# Environmental Defense Institute

January 8, 2018

**RE: Supplementary Public Comments for the Record on U.S. Department of Energy Interpretation of High-Level Radioactive Waste** <sup>1</sup>

Submitted by Chuck Broschous, President Environmental Defense Institute: [edinst@tds.net](mailto:edinst@tds.net)

**Tc-99 Concentrations Over Time at Various Monitoring Well Locations** [NRC, 2006, Figure 21a Pg. 95]

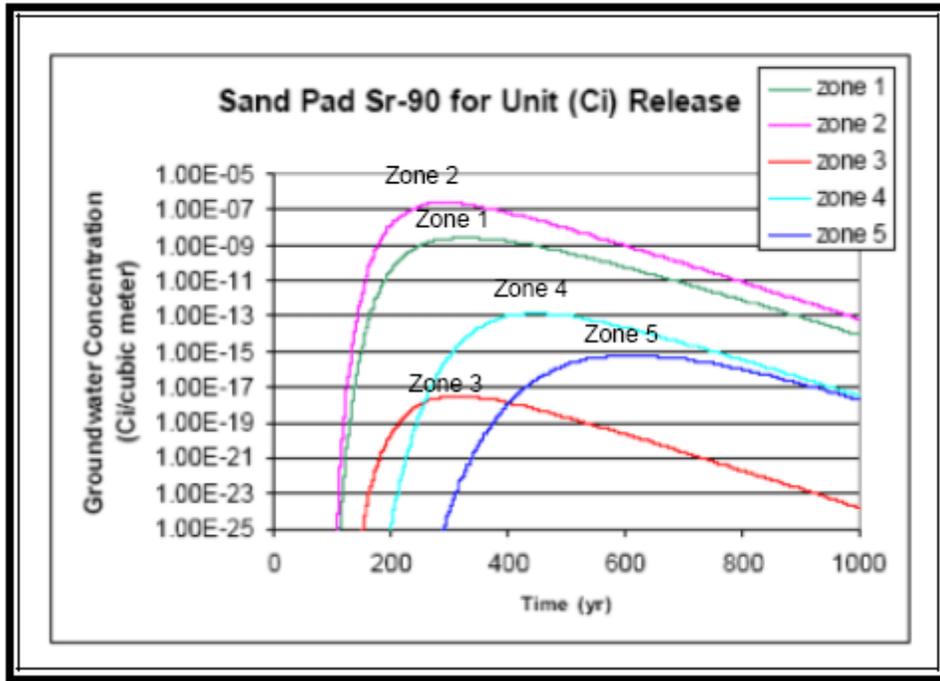
“The location of a newly installed monitoring well (ICPP-MON-A-230 located north of the TFF, see Figure 7) where elevated Tc-99 groundwater concentrations were detected, suggested that Tc-99 contamination linked to a TFF piping release (see CPP-31 release site on Figure 6) may have entered the [Snake River Plane Aquifer] SRPA significantly closer to the TFF.

“Additionally, a newly constructed well located 1,500 ft from ICPP-MON-A-230 also indicates that the extent of the Tc-99 plume is more widespread than originally thought (DOE Idaho, 2006e).

Figure B-7. Probes installed in the Activated Metals Focus Area in Soil Vault Rows 12 and 20.

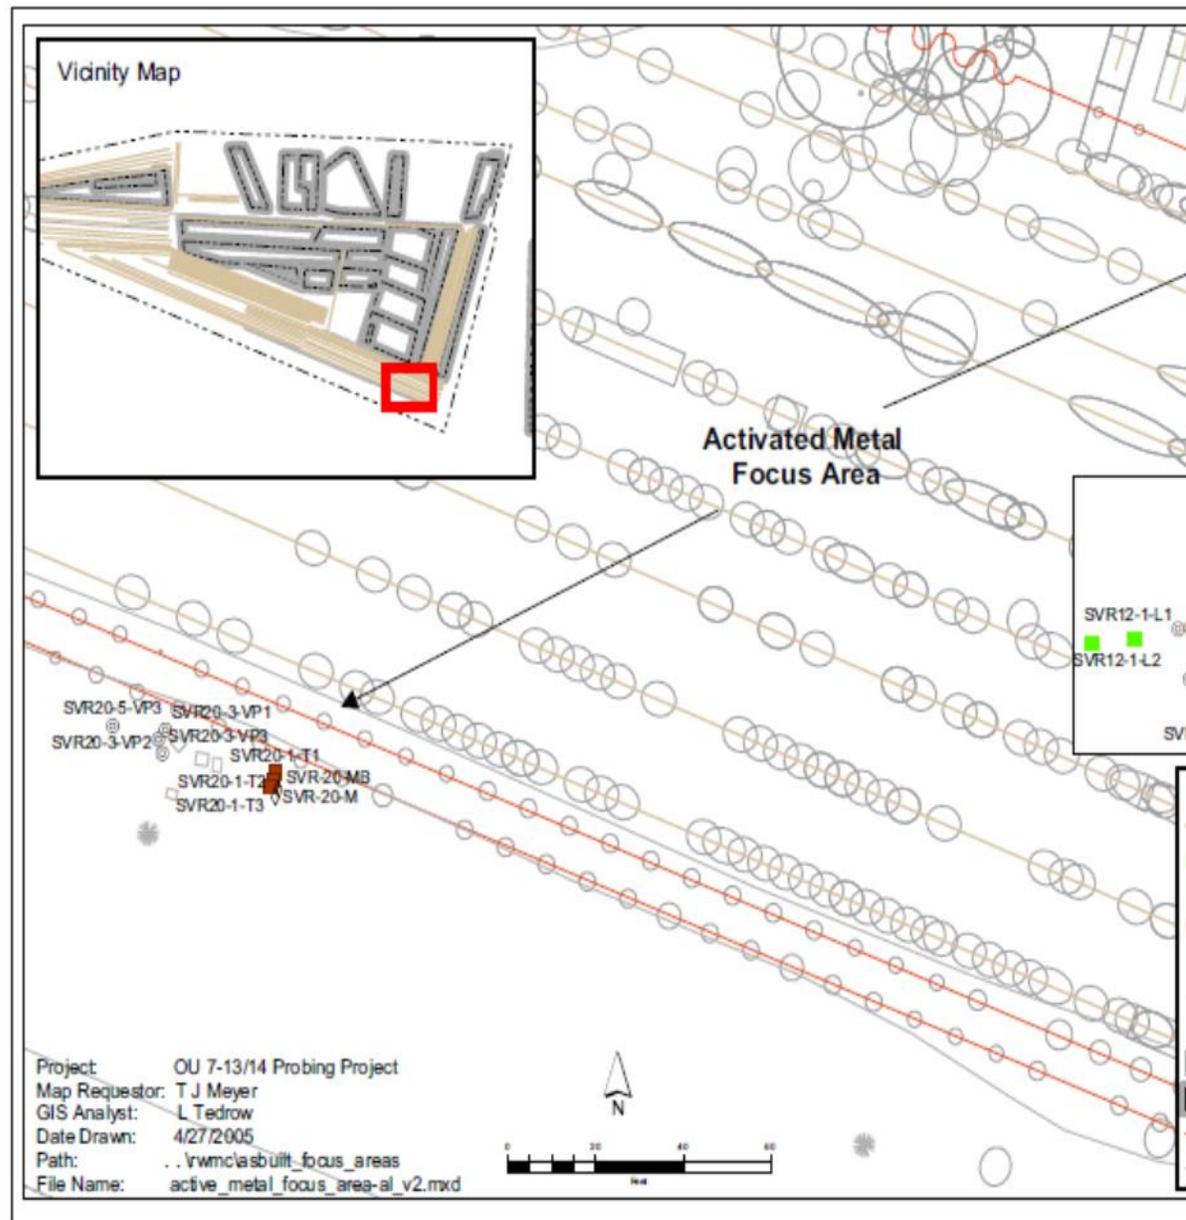
Figure B-7 above probes shows a closer look at soil vault probes that Agencies erroneously decided not to include in the SDA cleanup. As discussed in the EDI's Review attached Section XI No Plans to Remove Soil Vault waste and the issue of "activated metals" and the issue of fires resulting from the waste in Section VIII. See below for data on the findings of those probes that should have convinced Agencies to expand the waste retrieval areas.

Figure B-8. Probes installed in the Enriched Uranium-Source Focus Area in the west end of Area 1A, Tren

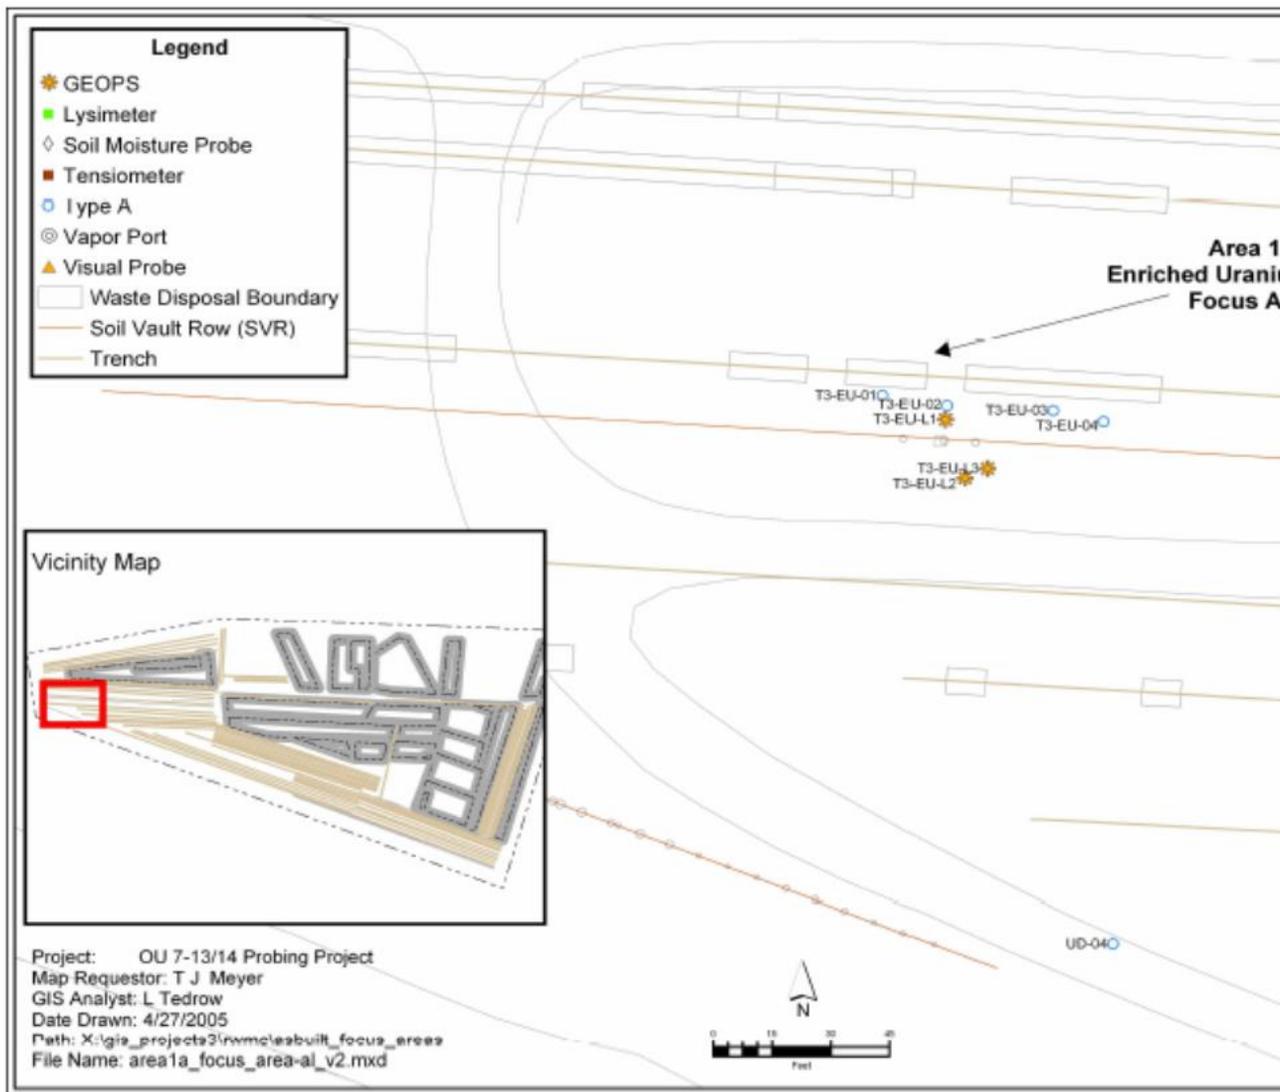
Figure B-8 probes show enriched uranium area that also apparently was not included in the retrieval area (no ARPS over these areas) and as discussed in the EDI’s Review attached Section XI “No Plans to Remove Soil Vault Waste.” Enriched uranium is a high-level and/or a TRU waste stipulated in the 1995 Settlement Agreement and DOE’s WMPEIS for removal to WIPP but excluded in the “Accelerated Retrieval Program” ARPs. DOE/INL has never admitted dumping high-level waste in the SDA; yet even their own SDA waste probes show it, if a person looks far enough into their documents.

Figure B-9. Probes installed in the Irradiated Fuel Material Focus Area in the west end of Area 1B, Trench 47.

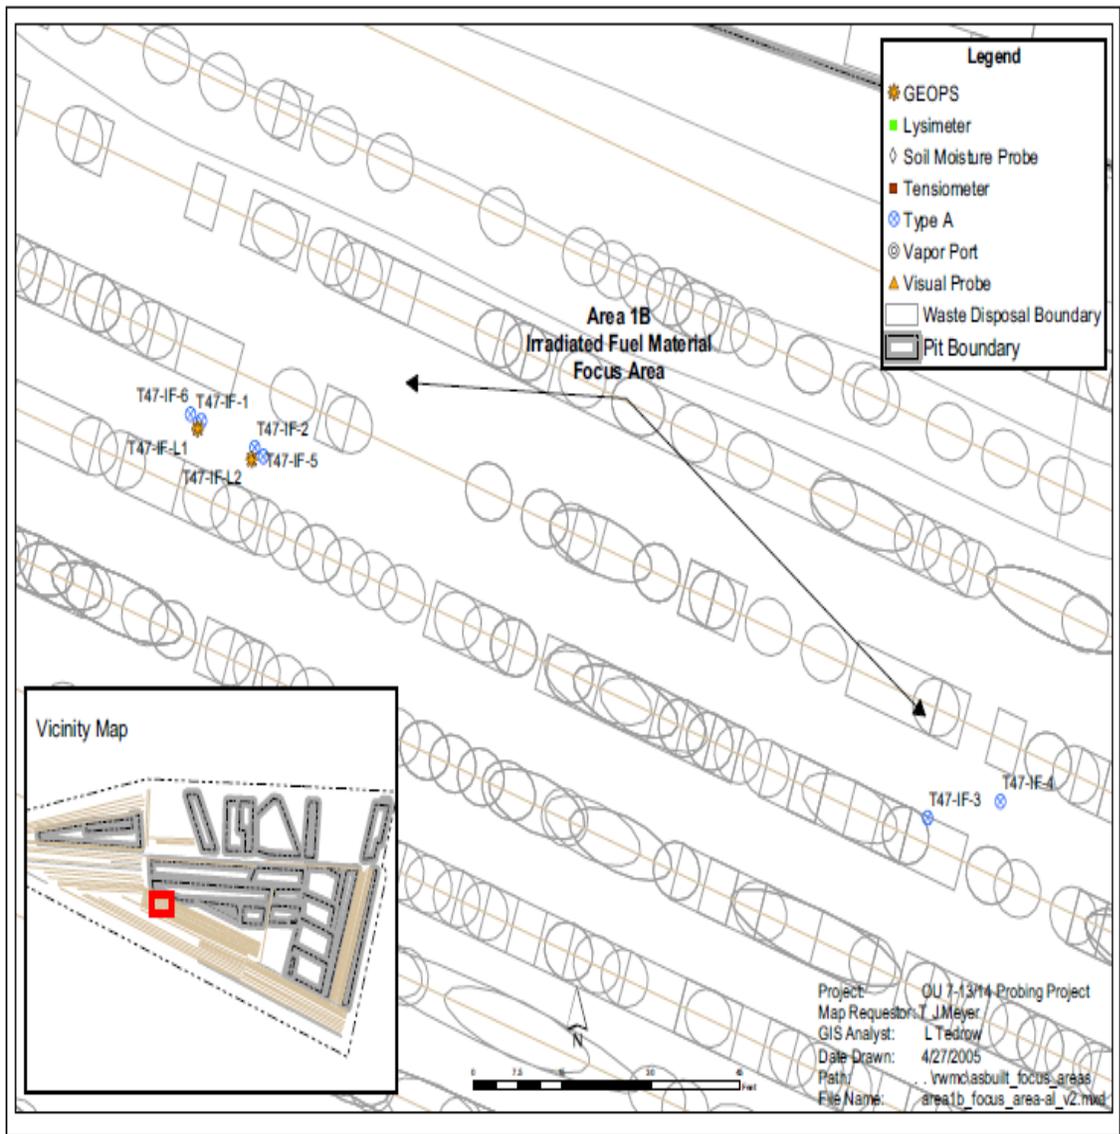
Figure B-9 above shows probes findings of irradiated fuel material area that also apparently was not included in the “targeted waste” Accelerated Retrieval Project (ARPs). Irradiated fuel is used spent reactor fuel that is classified as high-level radioactive waste that legally (according to NRC) must be disposed in a deep geologic repository because of its intrinsic biological hazard to human contact for thousands of years. As discussed in the EDI’s Review attached Section VI “No Plans to Remove Soil Vault Waste” on page 57.

Figure B-10. Probes installed in the Unrecorded Disposal Focus Area in the west end of the Subsurface Disposal Area, Area 1D.

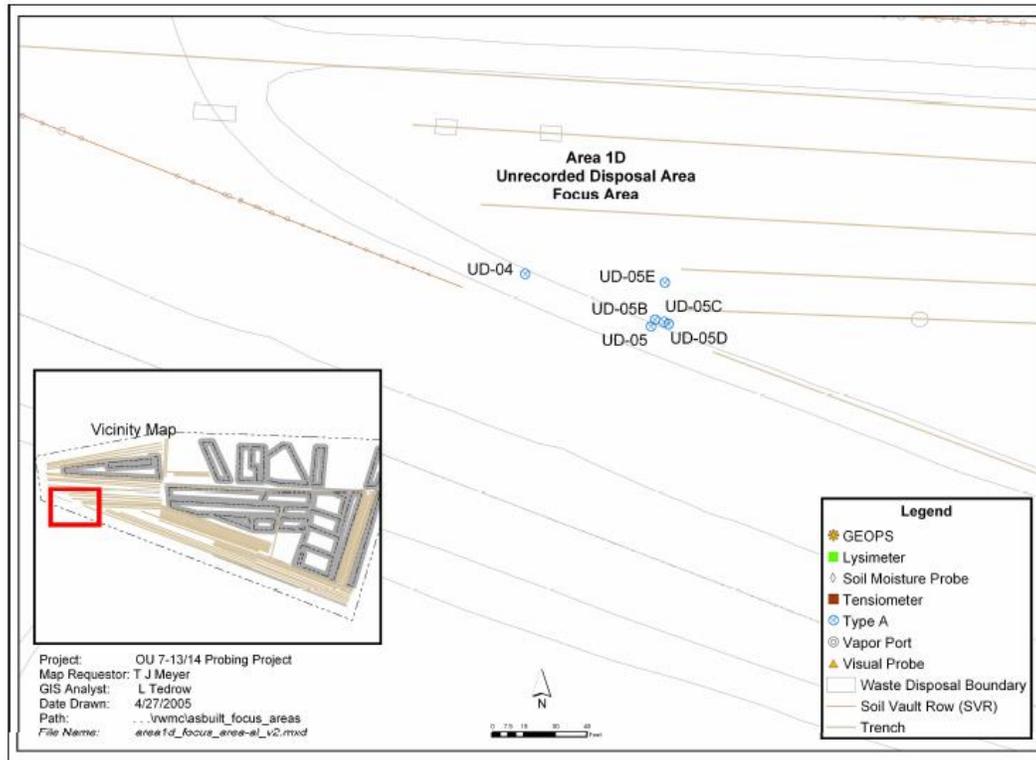
Figure B-10 above shows probes findings of unrecorded (previously unknown) disposal area that also apparently was not included in the targeted waste ARPS. Agency dependency on historical records on what and where this extremely hazardous waste is buried is unjustified. These ICP-EXT-05-00784 excerpts are only a tiny examples of what is available in this report that show how wide spread this type of “unknown” waste is distributed in the SDA. INL RWMC/SDA practices between 1950 to 1970 was anything gets dumped into whatever pit/trench was open at the time with no limit on how radioactive it was. “Just dump it and cover it up.” This included whole reactors from the 52 built/operated over the history of the site – originally called National Reactor Testing Station. Also many off-site reactors were dumped in the SDA. See EDI’s Citizens Guide to INL for a historical account of the site’s operations. <http://environmental-defense-institute.org/inlguide.html#Citizens%20Guide%20to%20INL>
